ADDENDUM No. 03

Subject: Wright Elementary School – Major HVAC Renovation
SDP Contract No.

This ADDENDUM dated 1/26/2022 shall modify and become part of the Contract Documents for the work of this project. Any items not mentioned herein, or affected by, shall be performed strictly in accordance with the original documents, unless modified by prior addenda, if any.

DRAWING NO.
AD103
SHEET 6 OF 69

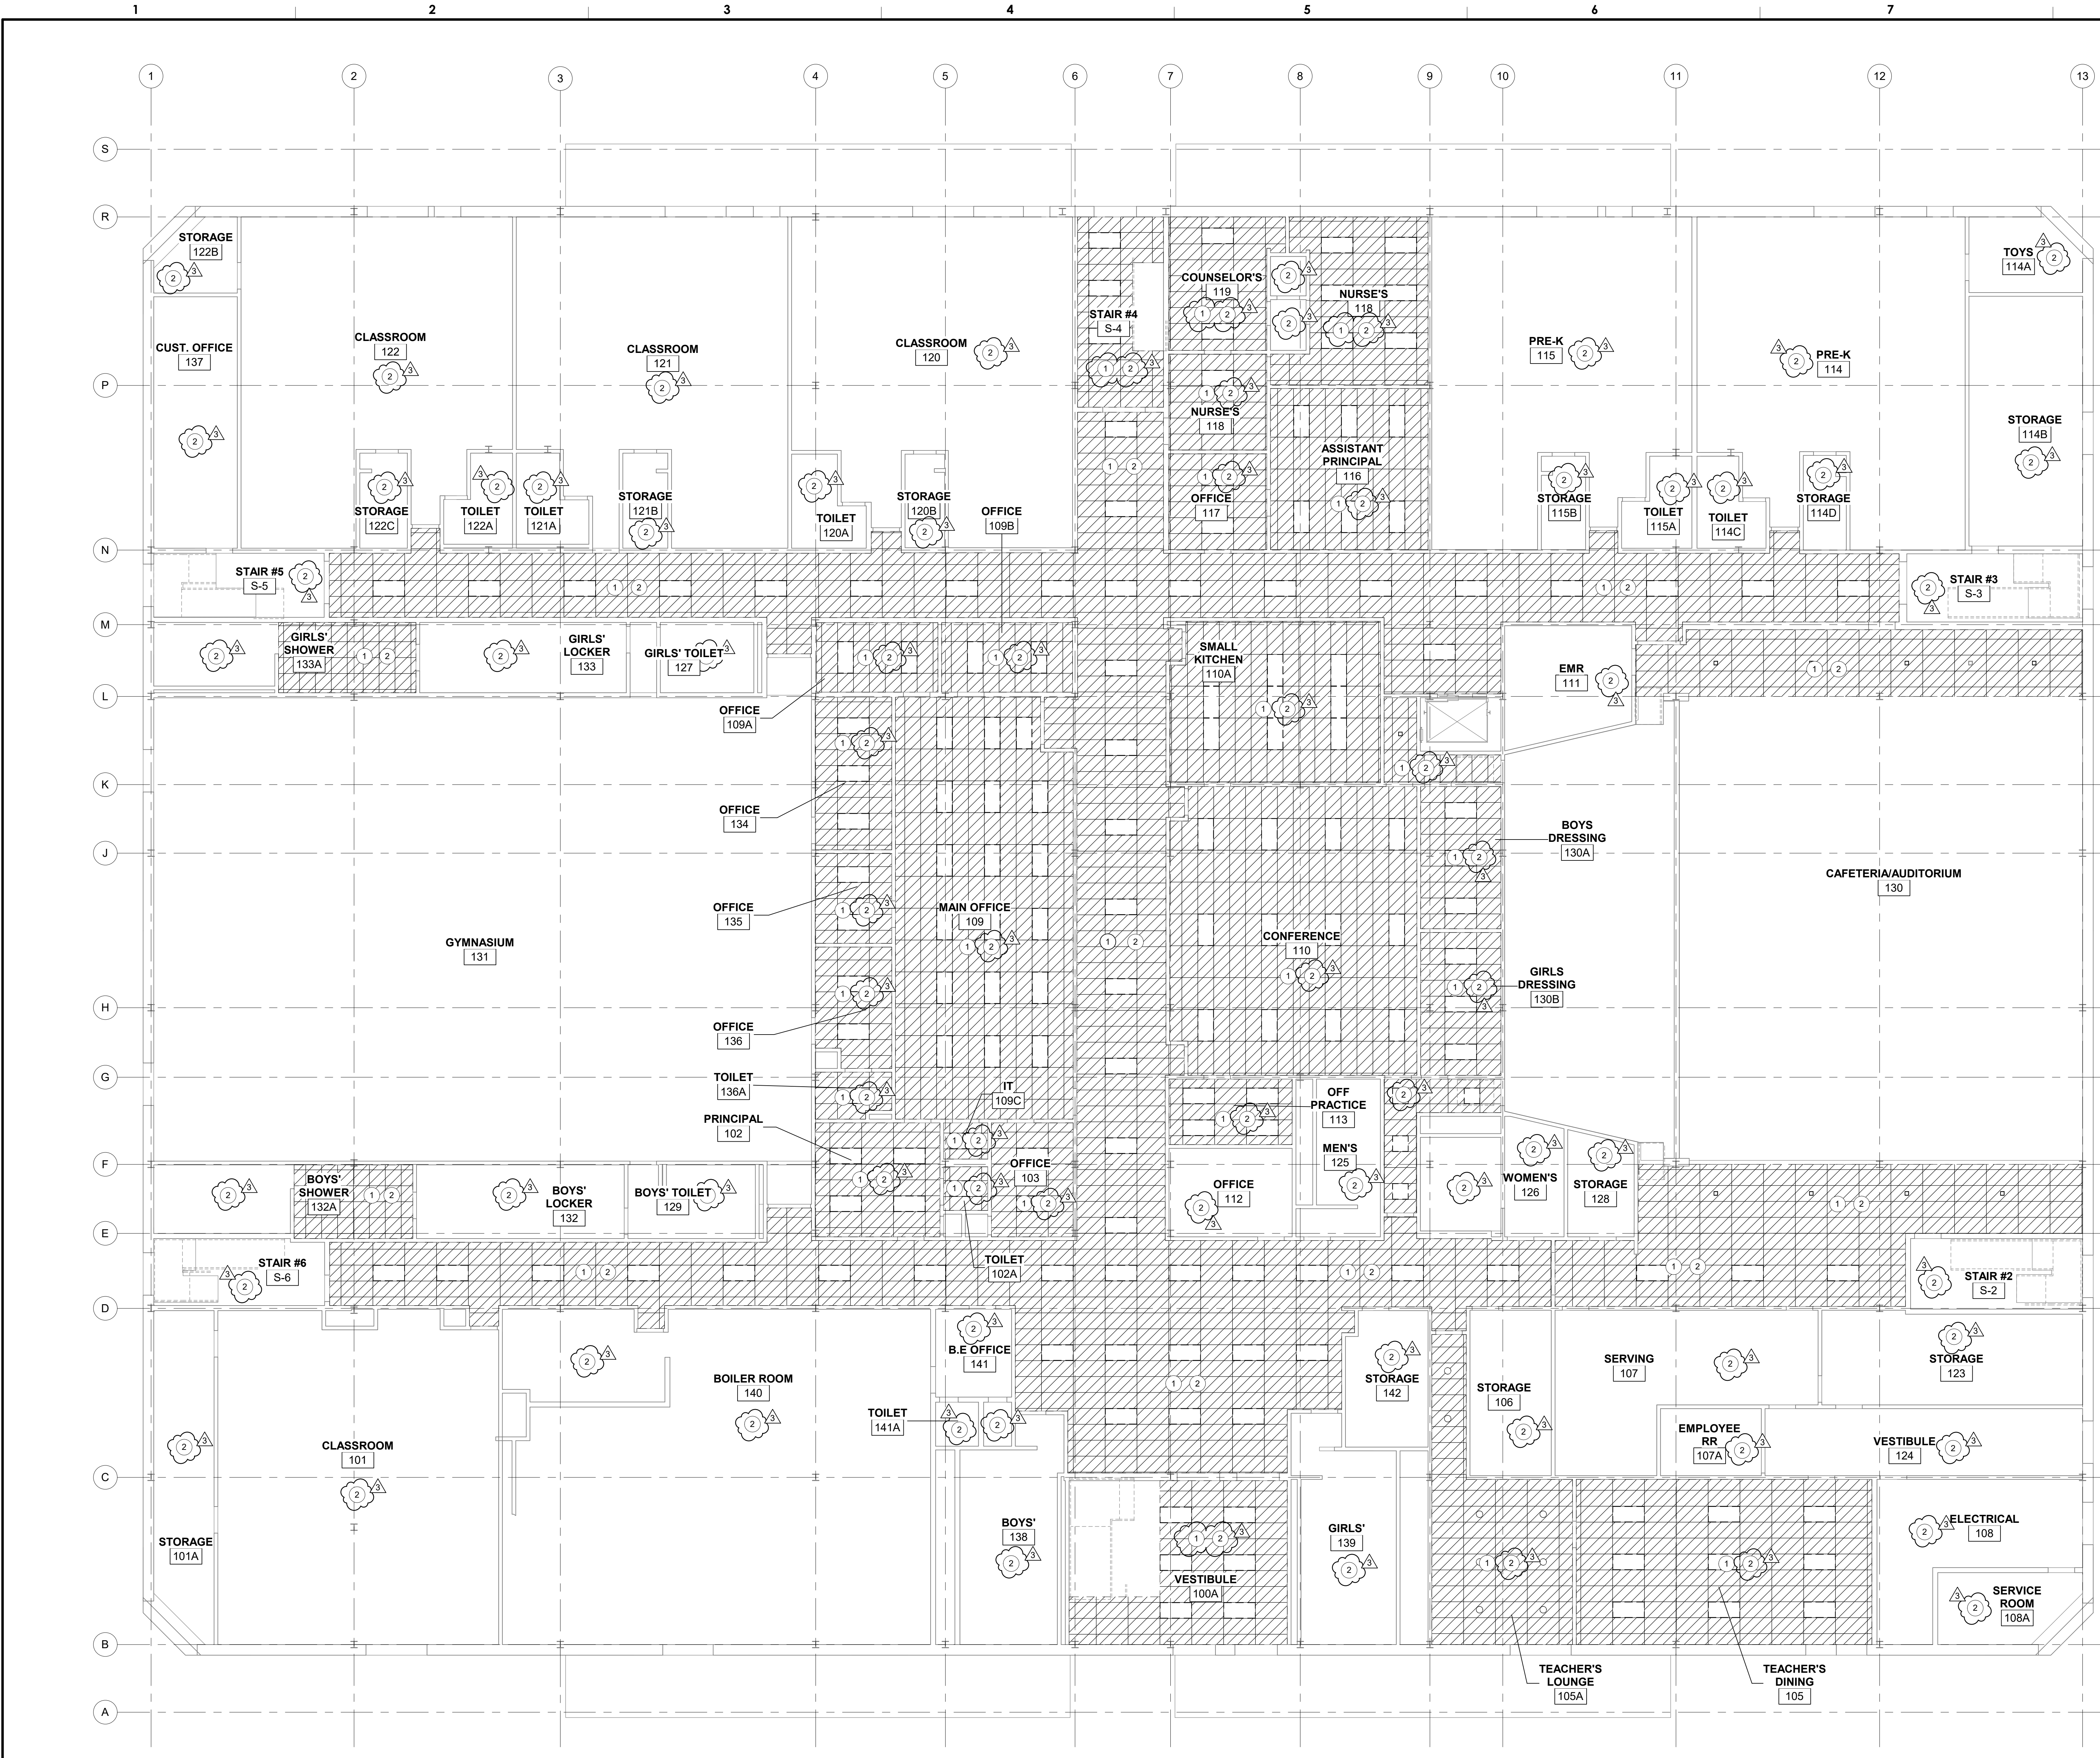
Drawing AD 103 & 104 show ceilings to be removed. Are all other rooms without ceilings since there is ductwork or piping to be removed from the room showing no ceiling removal. Please clarify.

Not all spaces have a finished ceiling (some are exposed). General Contractor is to remove and replace all ceiling tiles as indicated. See attached AD103, AD104, A103, and A104 as amended.

DRAWING NO.
A103
SHEET 11 OF 69

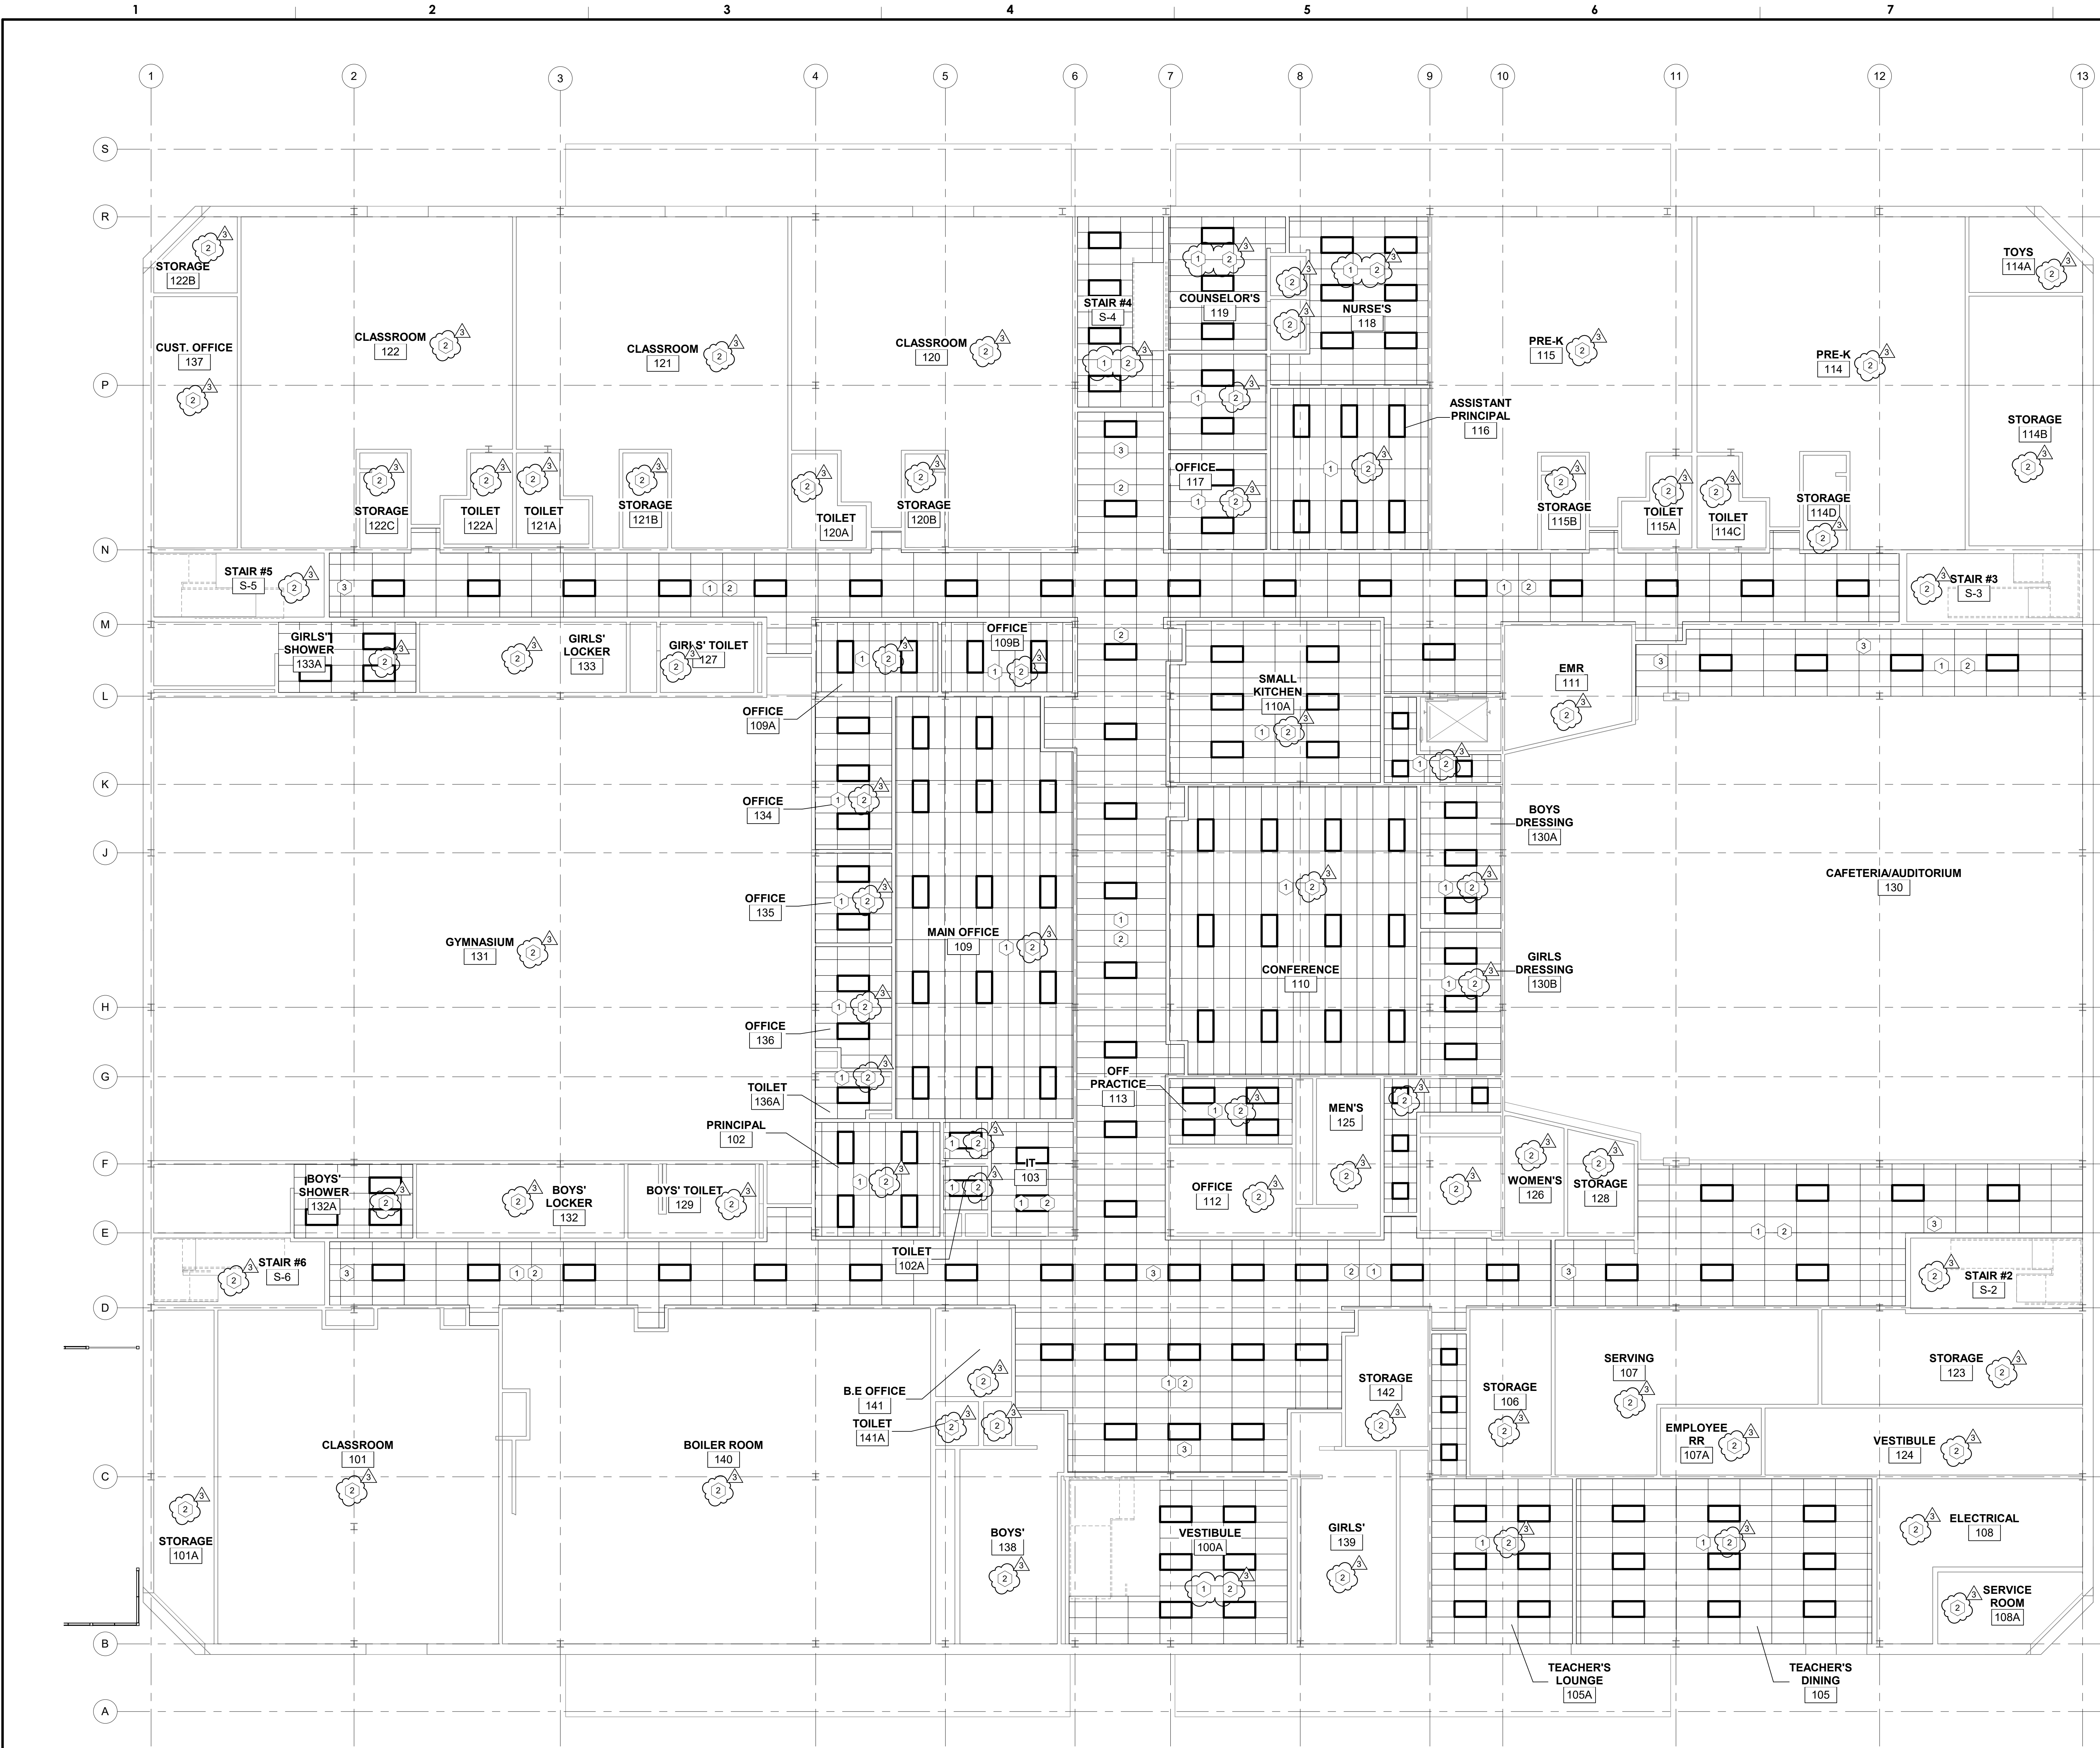
Drawing A103, A104 – Keynote #2: “Provide new 2’x4’ lay-in”

- a) Are we purchasing new light fixtures for these areas
- b) Can you provide a lighting drawing with locations?
- c) Can you provide a model number and any required controls?

Electrical note 5 on Plans E102 & E103 notes that all Light Fixtures in given rooms will be removed and reinstalled in new drop ceiling. However, when referencing the Architectural RCPs A103 & A104, these notes indicate that the some of the 2x4 lay in fixtures and exit signs are to be replaced with new. Which is correct?

a) The Electrical Contractor shall remove existing lighting and provide new lighting throughout the facility. See attached EL drawings.
